4727 12th Avenue NE
APN: 674670-1970
Zoning: SM-U 75-240 (M1)
Overlay: University District NW Urban Center Village
Lot Area: 4500 sf
Current Use: Single Family Residential

EDG RESPONSE

BASEMENT LEVEL PLAN SHOWING INTERNAL TRASH ROOM

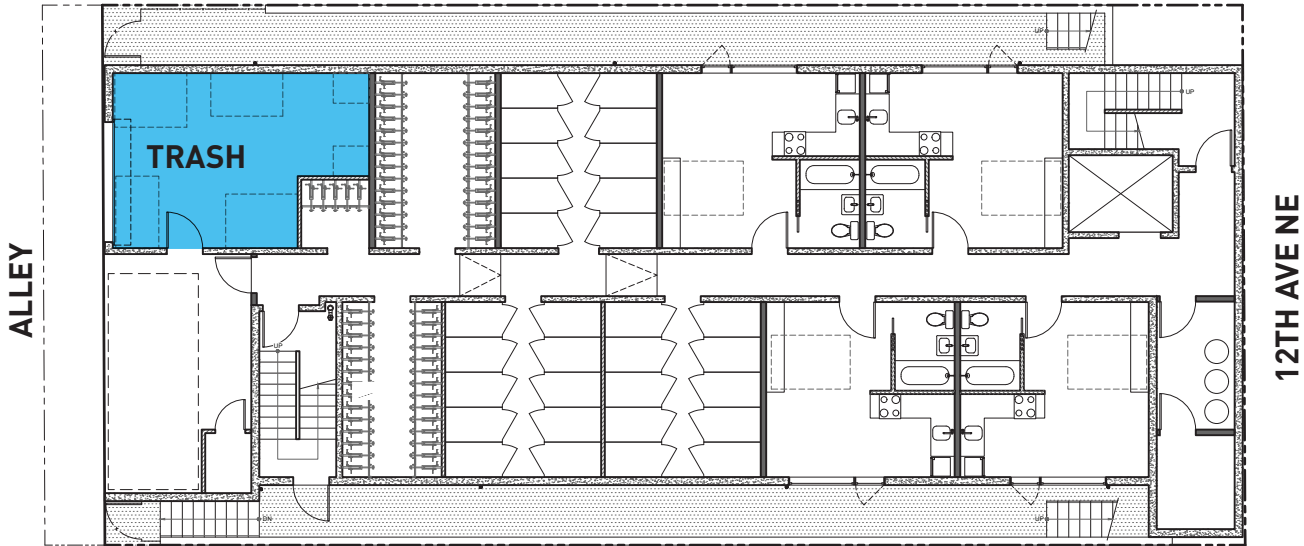
- a. The Board directed the applicant to create an enclosed trash room within the building footprint or within the footprint of where it is currently indicated on page 29 of the EDG packet. The Board was also supportive of either relocating the trash room to the area of the mechanical room or placing it in a more centralized location making it easier to install a trash shoot as a viable alternatives. (CS2-II).

The trash room is now enclosed within the building footprint, accessed for pick-up through a large coil-up door. This minimizes impacts to adjacent properties. A centralized location proves to be impossible to service adequately, again due to the narrow width of the site. The location at the alley keeps trash out of the core of the building and provides easy access for pick-up. While we recognize the convenience that is offered by a trash chute it is not a requirement and is not provided. We worked with Seattle Public Utilities on the configuration and size of the trash room to satisfy their requirements for access and pick-up and have secured their approval of the layout.

SOUTH ELEVATION WINDOW ADJACENCY DIAGRAM

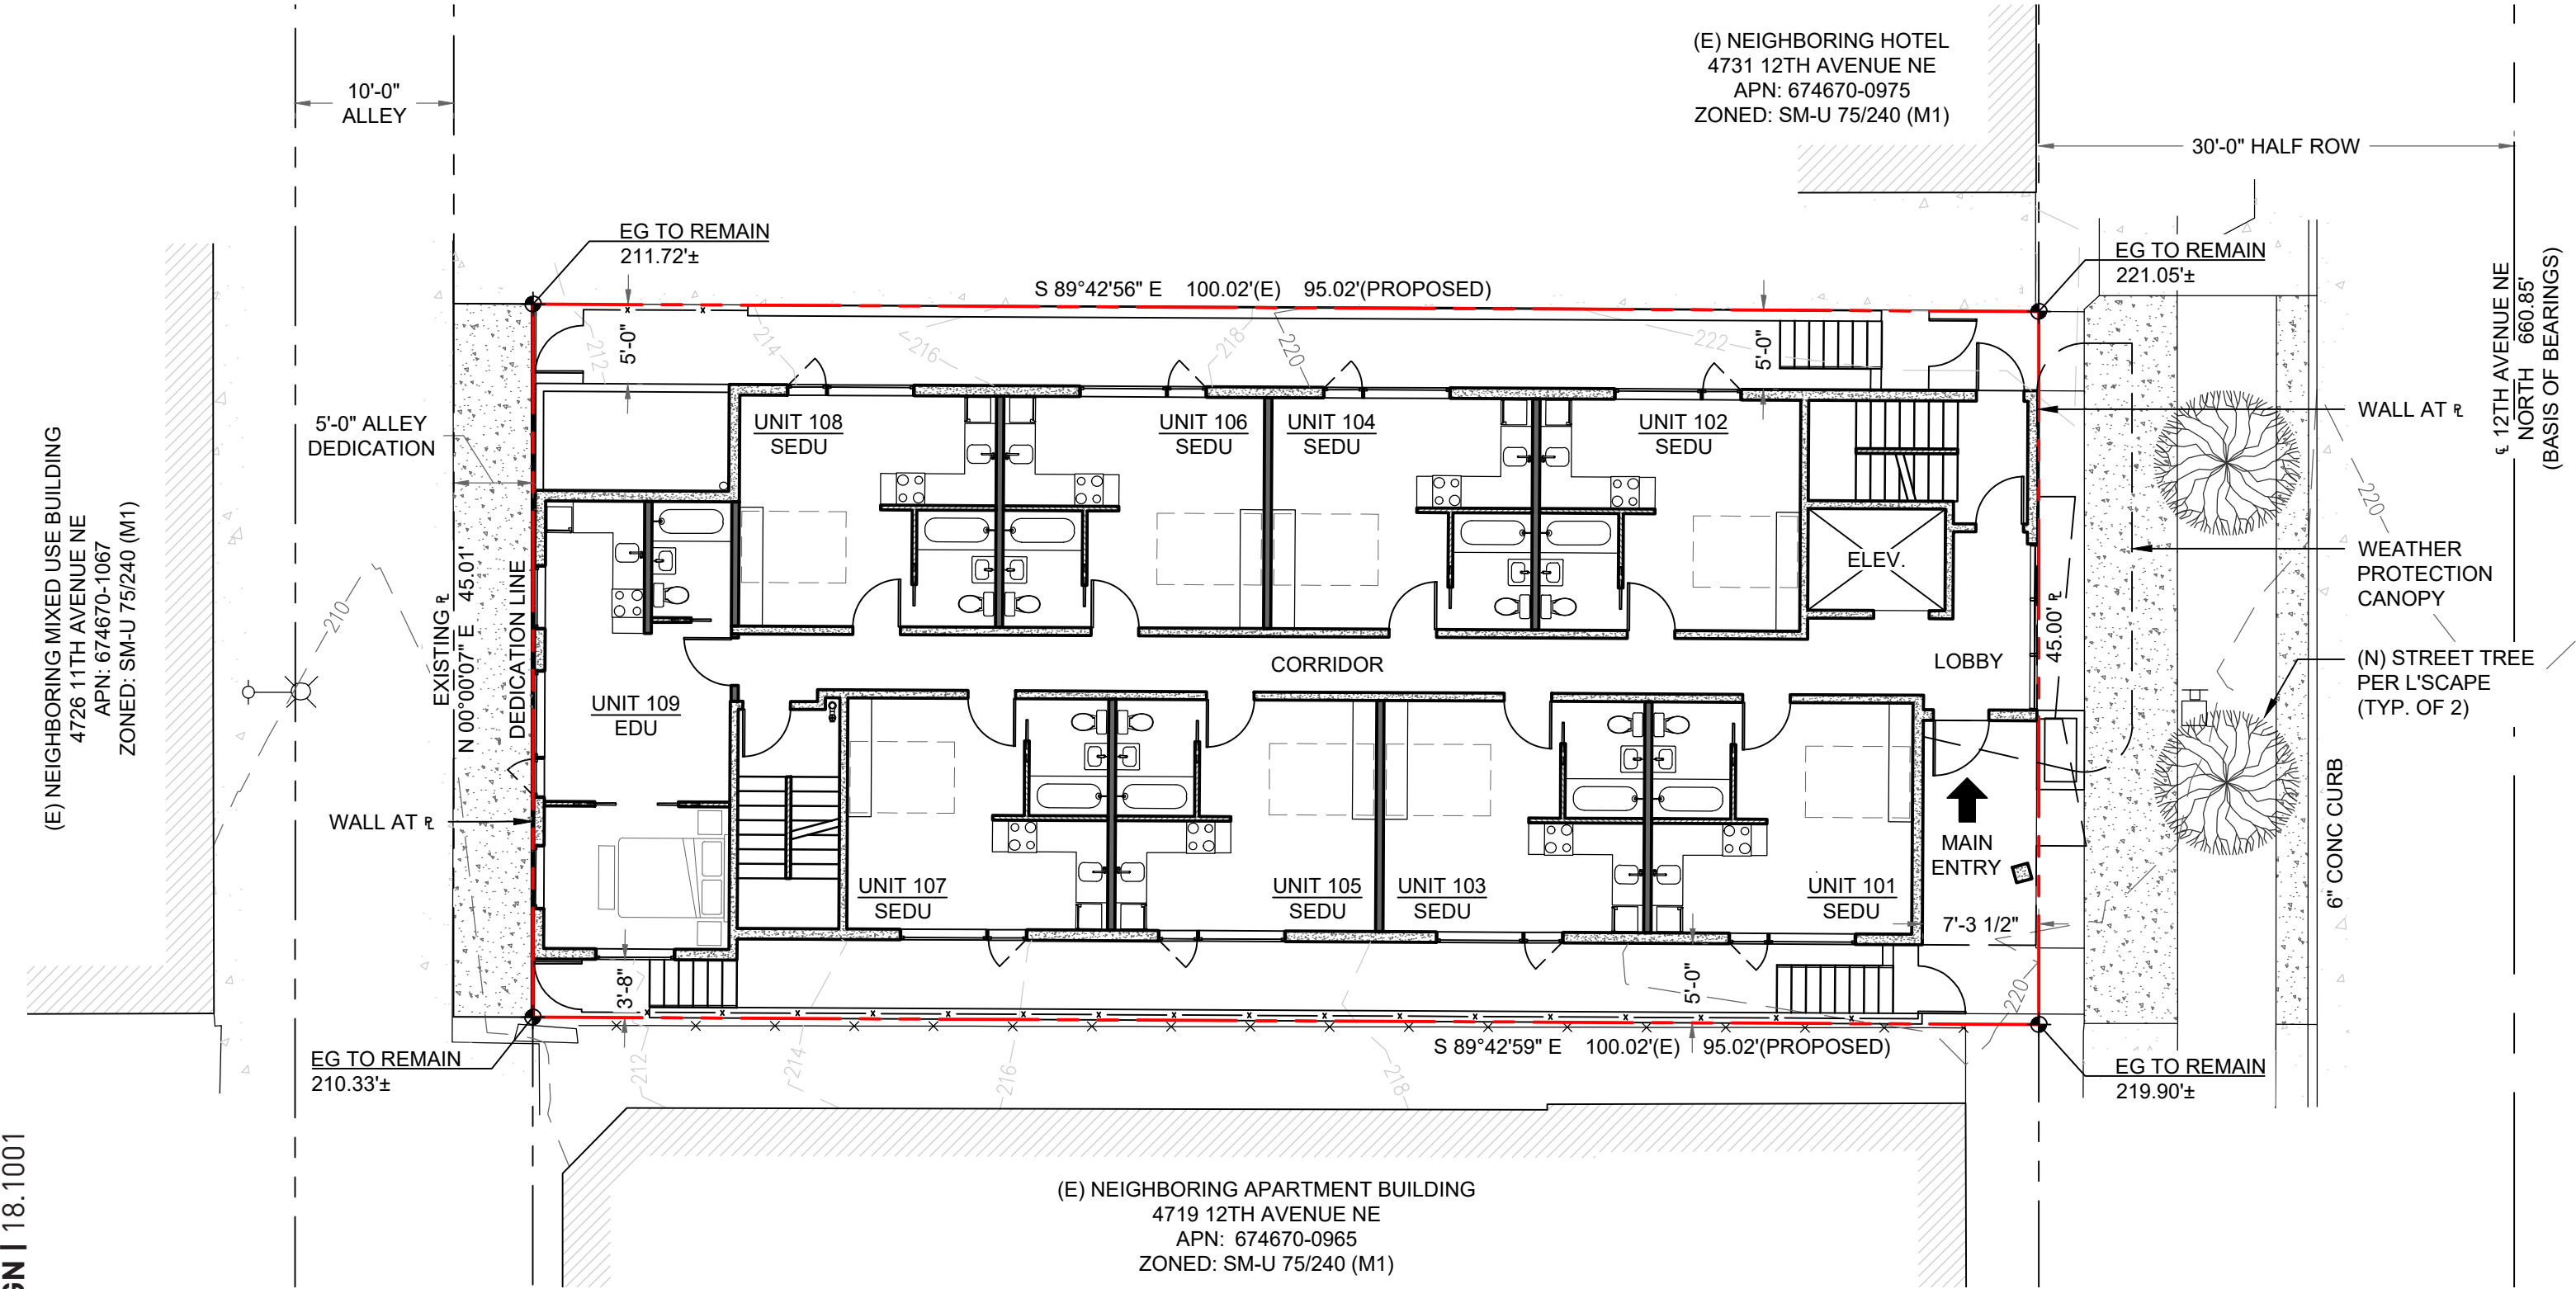
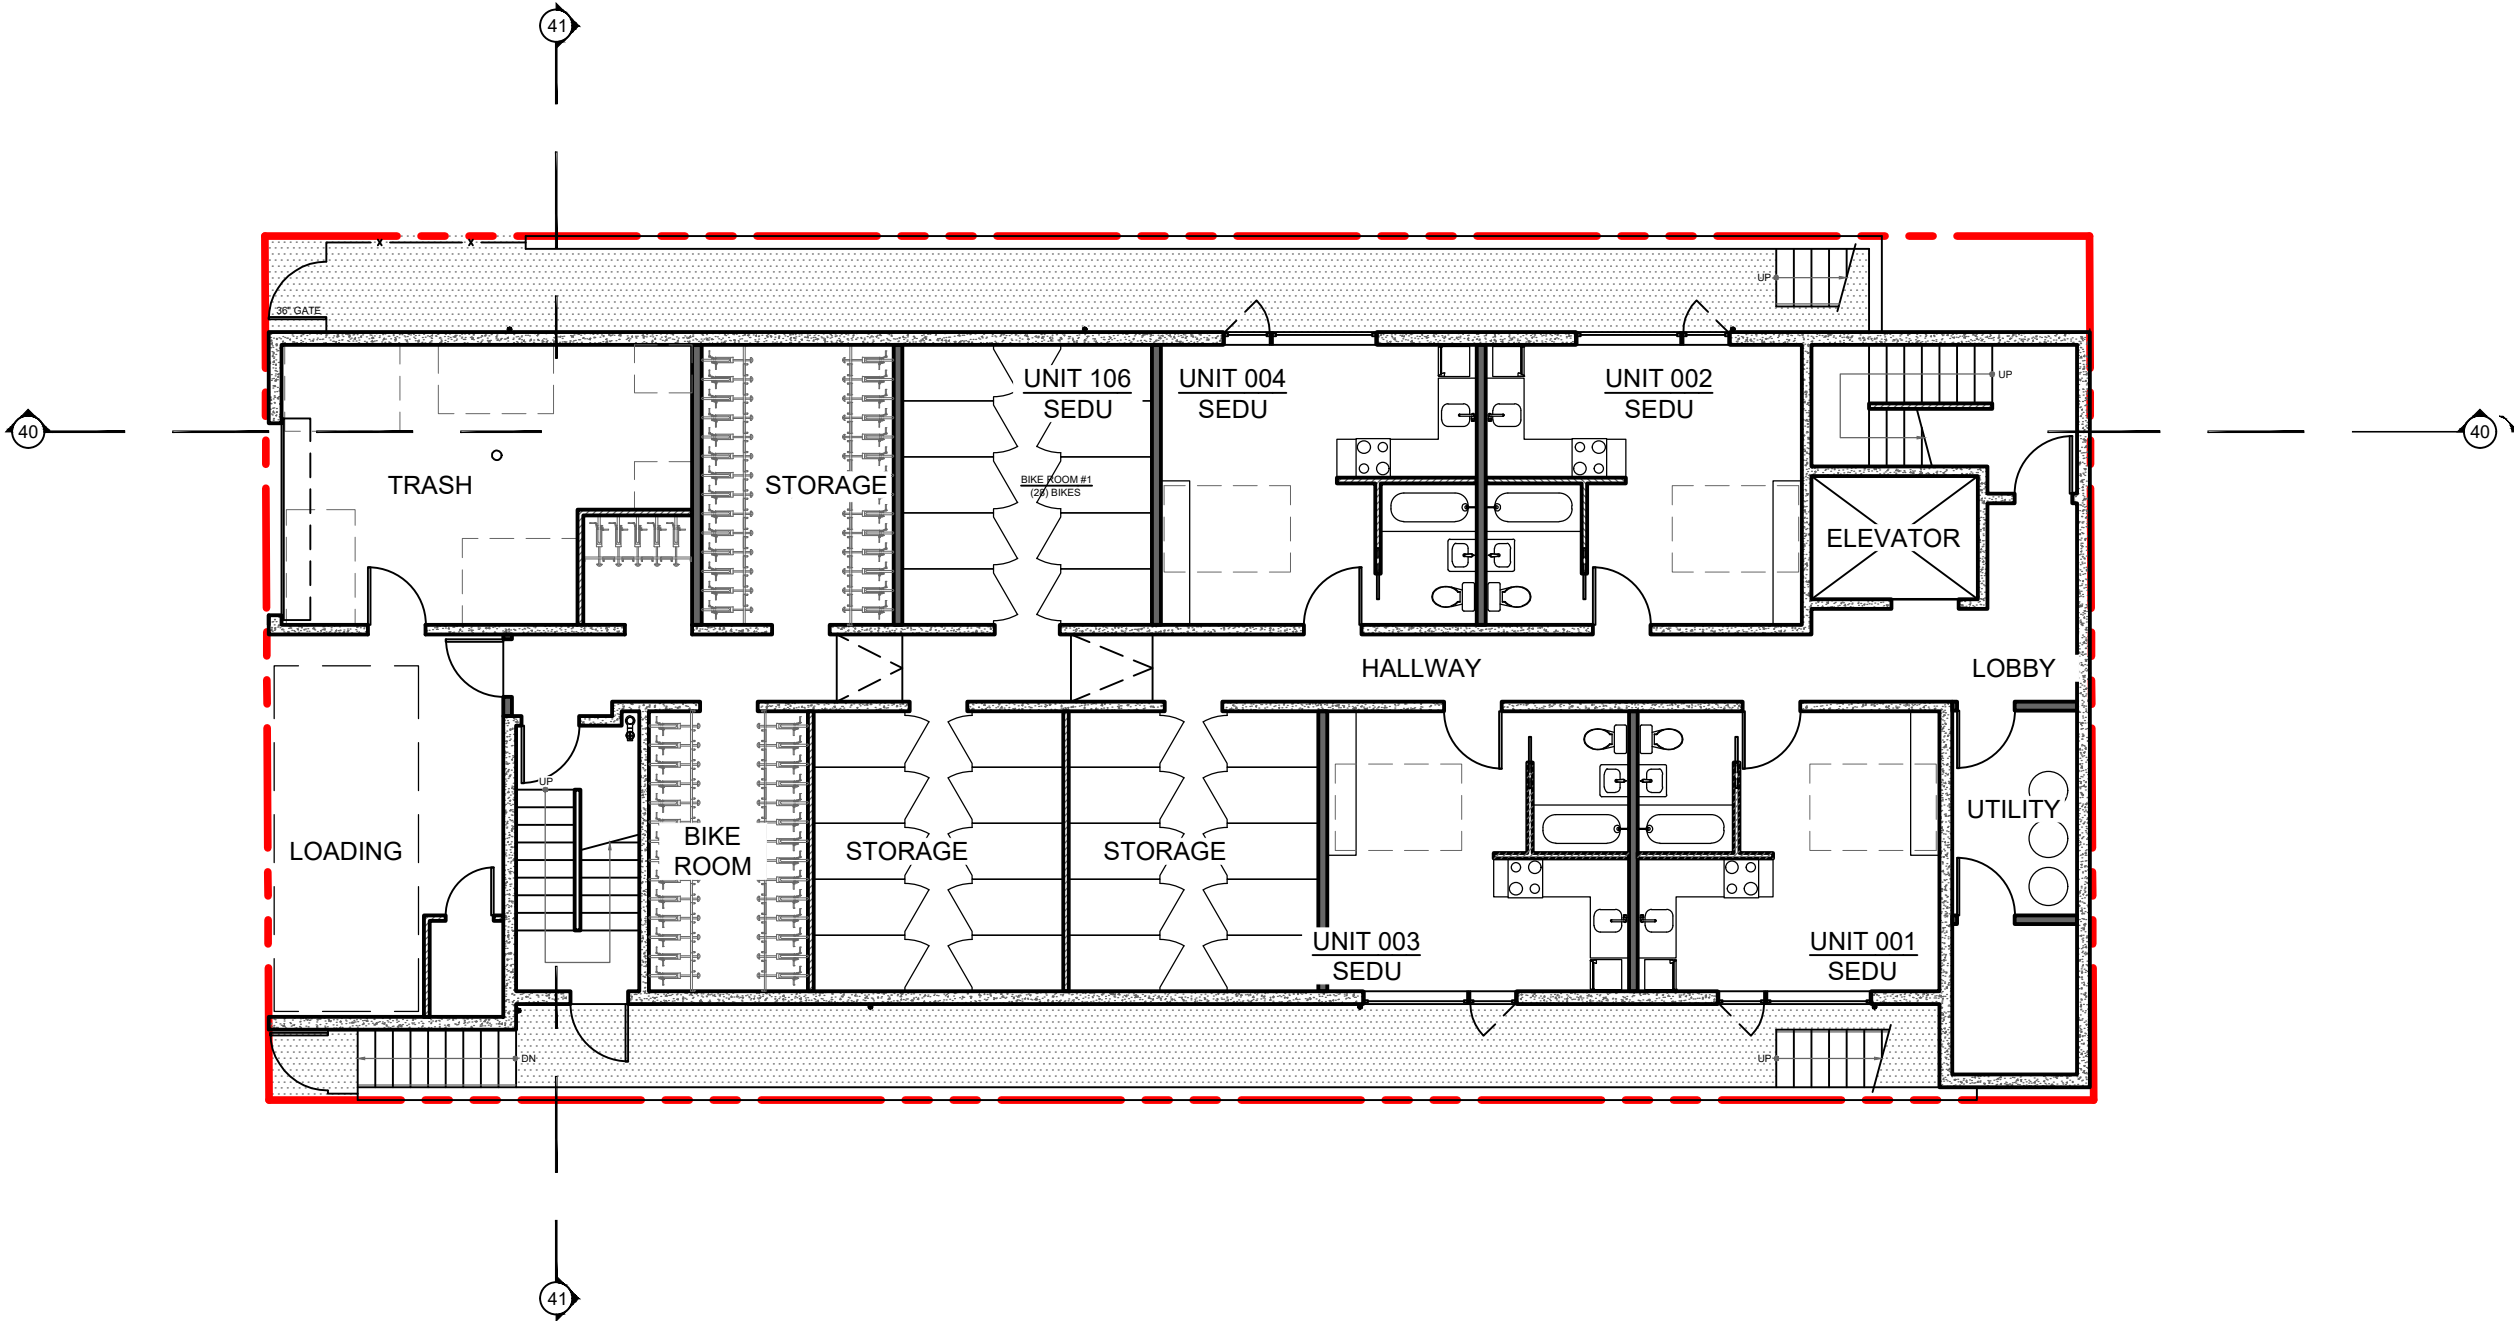
The Board observed that the design proposal did not meaningfully respond to the close proximity of the elevator corridor of the building to the south. The Board thought the units on the south facing façade might be too close to the adjacent building and suggested further review of the floor layout and possible relief to the stack of units that would look out directly onto the adjacent elevator core. The Board agreed with the public comment that the ‘sunken’ walkways located along the north and south of the building could be used as throughways and loitering spaces for transients as they have direct access to the alley. Board members discussed how the spaces could possibly be broken up with a combination of hardscapes, softscapes, or terraced landscaping instead of stairs in order to make the spaces less of an attractive area but decline to make this a specific directive.

- a. The Board stated that they would like to see gates installed to discourage any unauthorized use of those walkway spaces. (PL2-B, CS2-II)

The elevation diagrams show the direct relationships between fenestration on the project façade and the adjacent buildings. Window spacing was modified to reduce overlap at the elevator tower and the patio doors of the adjacent building. Gates have been added to limit and discourage access to the sunken side yard spaces. We are maintaining the stairs from the window wells to maximize ease of egress in case of emergency.
